Proposed Residential Development  
Land at Chichele Road, Oxted

**Appendices to Proof of Evidence of Andrew  
Whittingham BSc (Hons), MSc, CEng, MICE**

Appeal Reference: APP/M3645/W/24/3345915

Stage 1 Road Safety Audit  
Prepared on behalf of Motion

C:\Users\JulianSmith\Motion\StaffSite - Coaxte 1907029\Drawings\1907029-04,05,06 [Traffic Calming].dwg

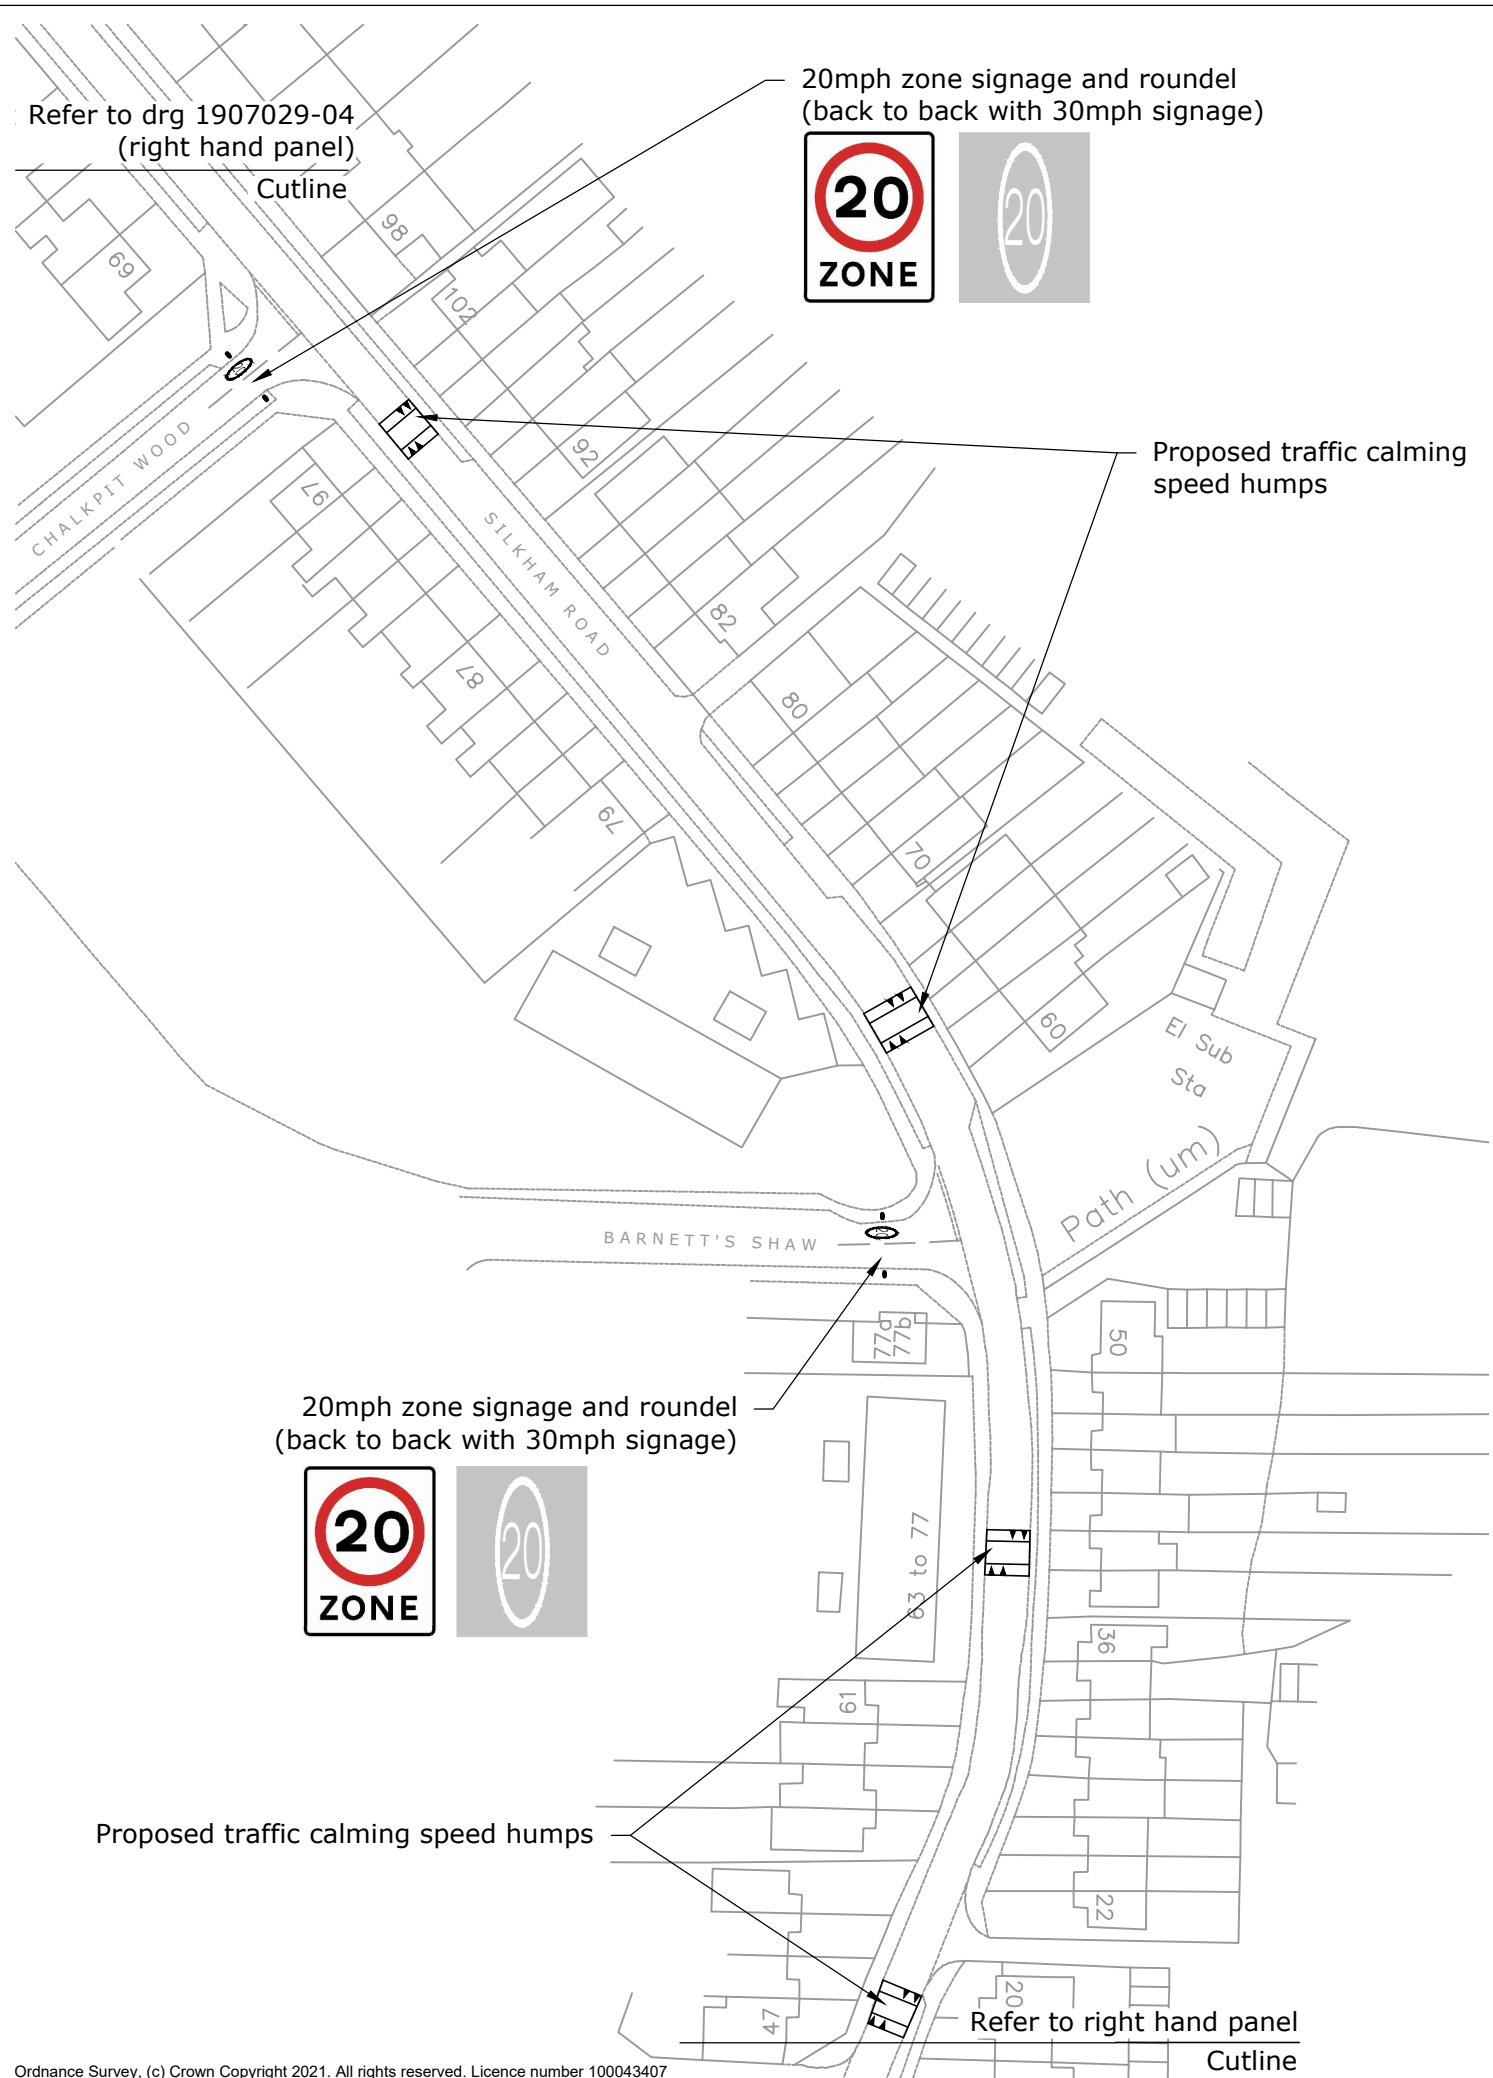
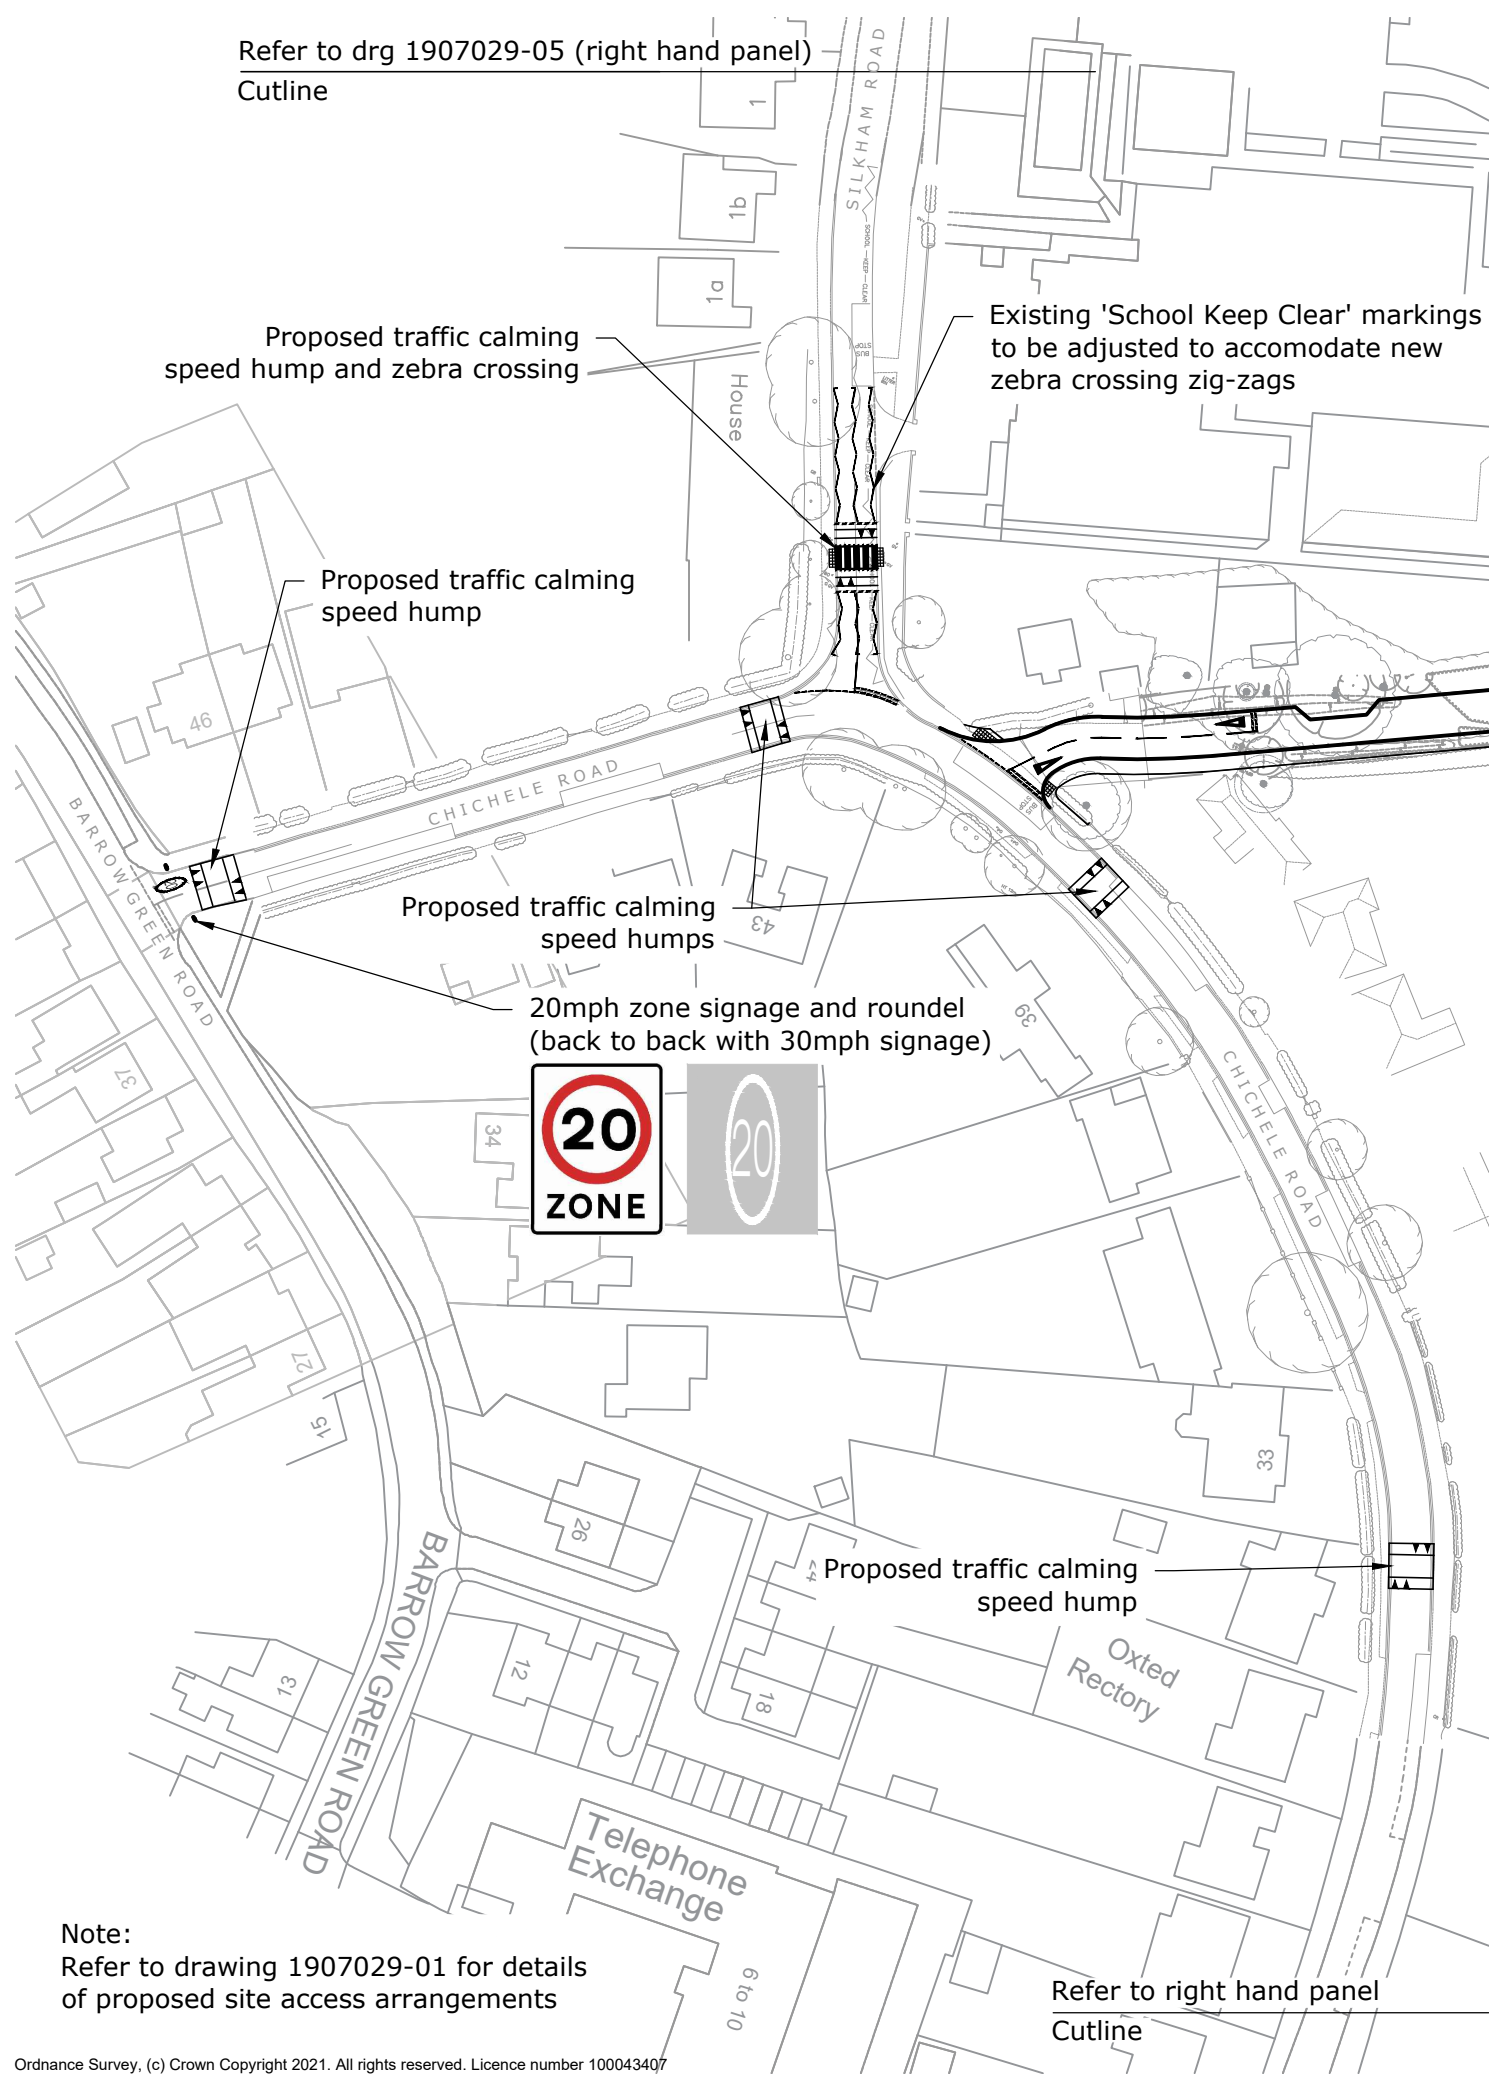
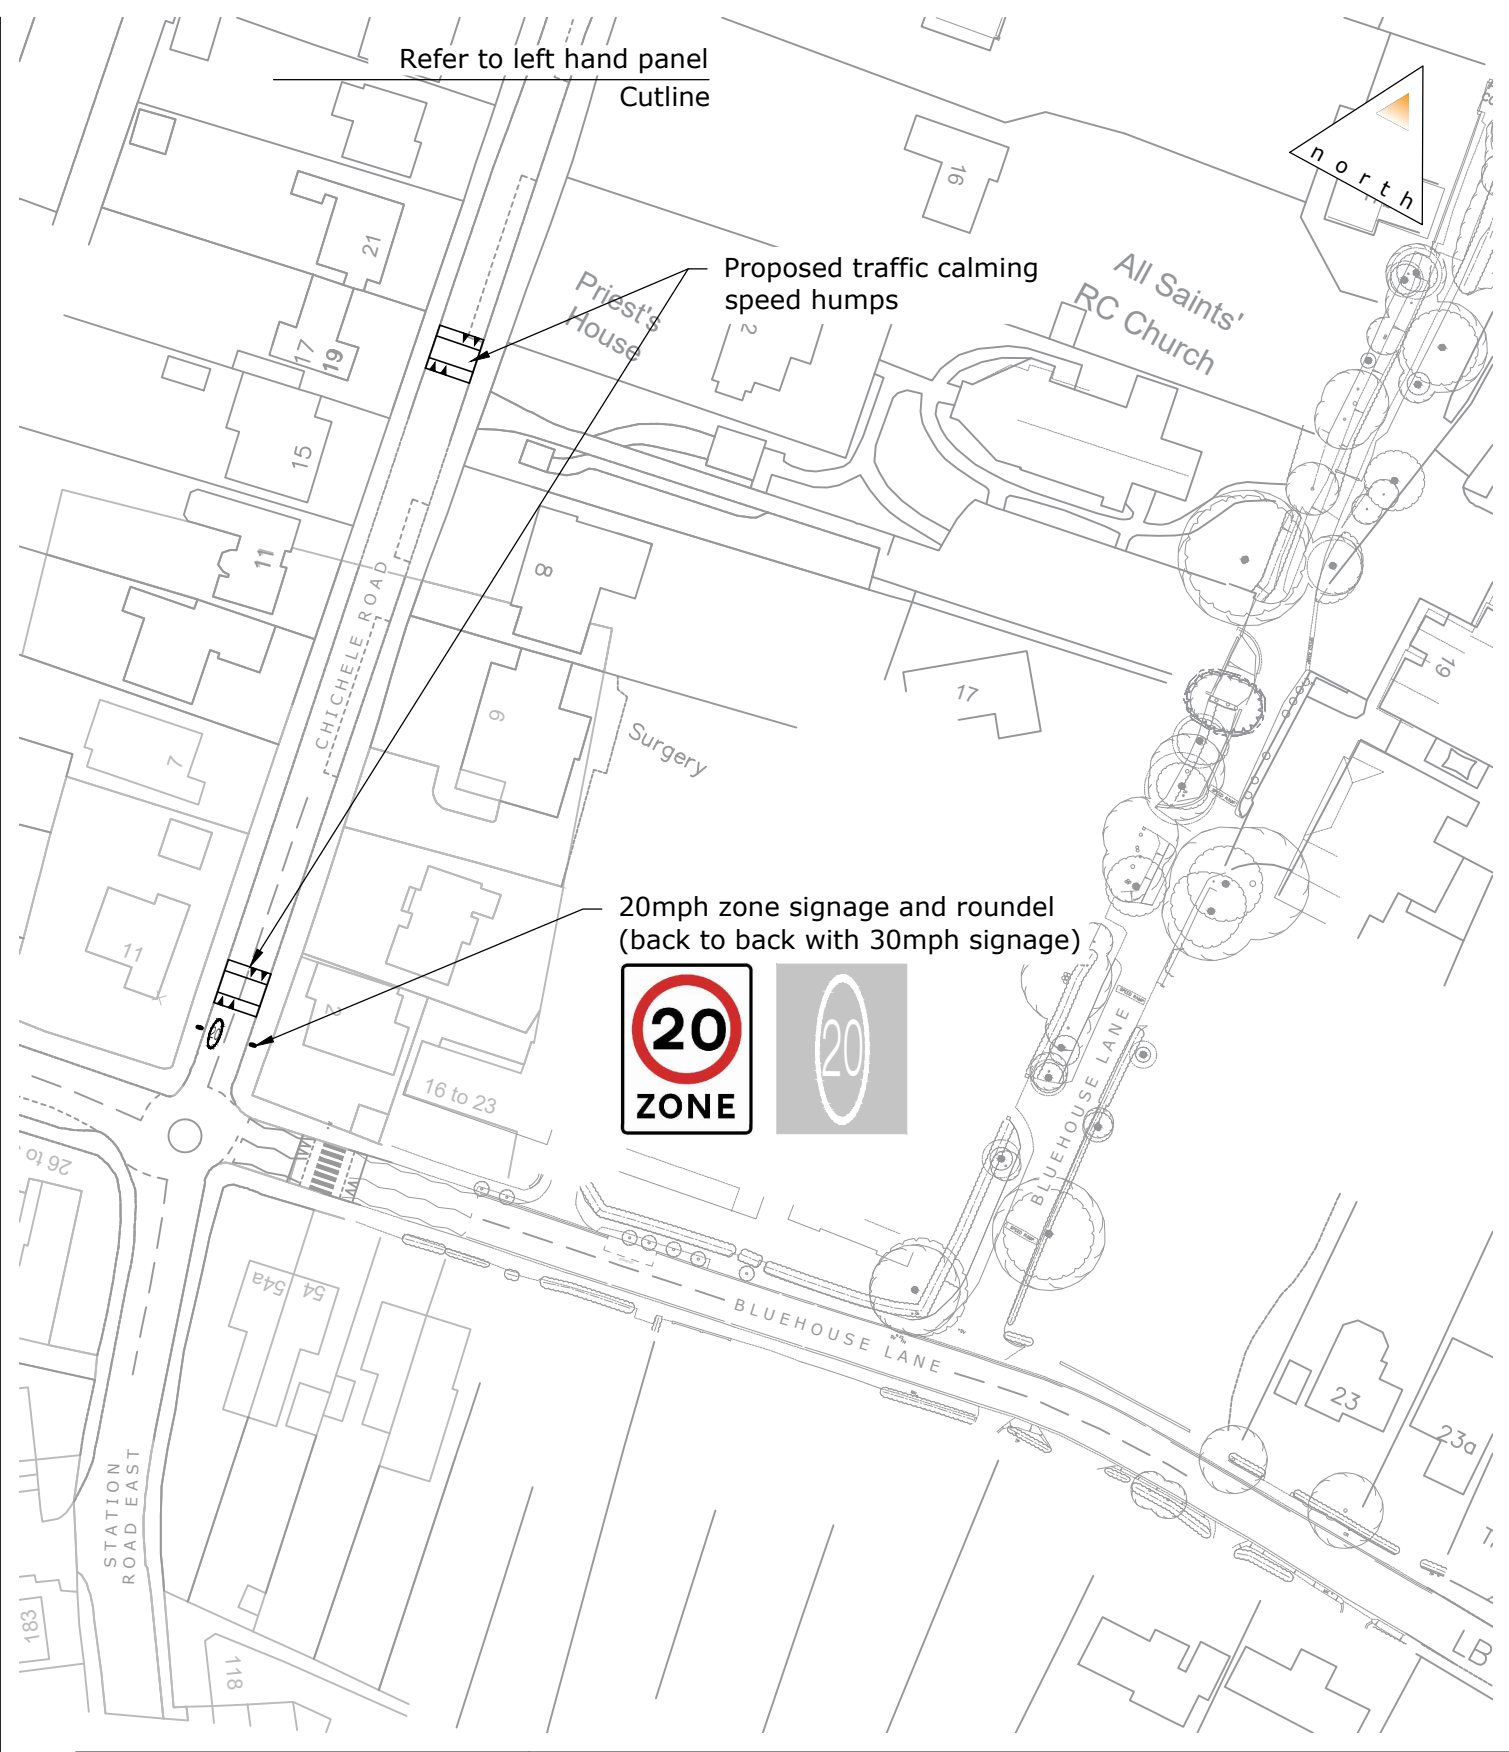
The limited junction separation between Silkham Road and the site access may lead to drivers misinterpreting the signals of turning vehicles. For example, a driver waiting to turn out of Silkham Road may interpret a left turn signal for the site access as a left turn for Silkham Road, leading the non-priority vehicle to pull out into the path of the priority vehicle. Similarly, a right turn signal for the site access may be interpreted as a right turn into Silkham Road, causing a following vehicle on Chichele Road to 'shunt' into the rear of the turning vehicle.

Introduce a local 20mph speed limit to reduce the risk of collisions and the severity of injuries and, if necessary, provide additional traffic calming measures on each approach. Suitable signage of the speed limit and traffic calming features should be provided. It may be appropriate to treat the entire junction arrangement as a raised surface with contrasting surface materials.

2.4	Introduce a local 20mph speed limit to reduce the risk of collisions and the severity of injuries and, if necessary, provide additional traffic calming measures on each approach. Suitable signage of the speed limit and traffic calming features should be provided. It may be appropriate to treat the entire junction arrangement as a raised surface with contrasting surface materials.	The proposals include a potential 20mph speed limit scheme within the vicinity of the site in the form of signage and raised tables along Chichele Road, Silkham Road and Central Way.
